Re: Rapiscan AIT System Radiation Survey Reporting

Rapiscan systems	Secure 1000 Radiation Emission Measurement	FORM R-0646-1 (Single Pose)
----------------------------	---	--------------------------------

R-0646-1 Addendum (Documentation Errors)

Product Name	Secure 1000SP (Single Pose)
Serial Number	S51038006
Radiation Emission Measurement	Radiation Survey Dated: 11/16/2010
RSO Initials

SV0002513
Form R-0646-1

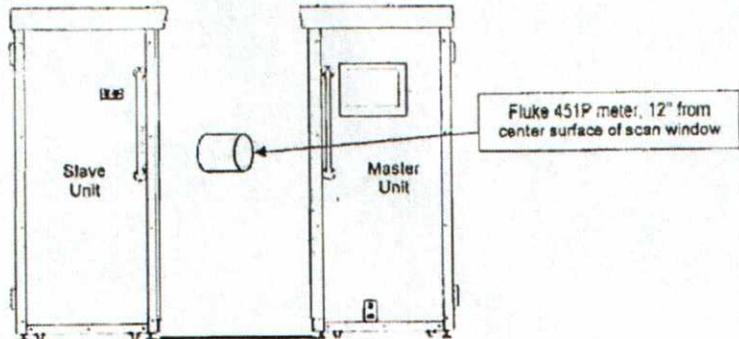
1. No value indicated for background radiation. Typical values range from 7uRem/hr to 13uRem/hr at sea level. Note: Absence of value has no adverse impact on calculations.
2. Technician indicated scan time as 7 seconds. Correct scan time is 3 seconds.
3. Technician did not note system parameters for kVP and mA. Correct values are 50kVP and 5mA.
4. TABLE 1: Incorrect presentation of data in Column 3 for Measured Exposure. Indicated values are 20uR and 12uR. Corrected values are 2.0uR and 1.2uR
5. TABLE 1: Incorrect presentation of data in Column 6 for Effective Dose. Indicated values are 11.5 uRem and 6.9 uRem. Corrected values are 1.15 uRem and .69 uRem.

The service technician should attend refresher training.

The corrected data indicates this system was operating within expected parameters. No re-survey is required for this system.
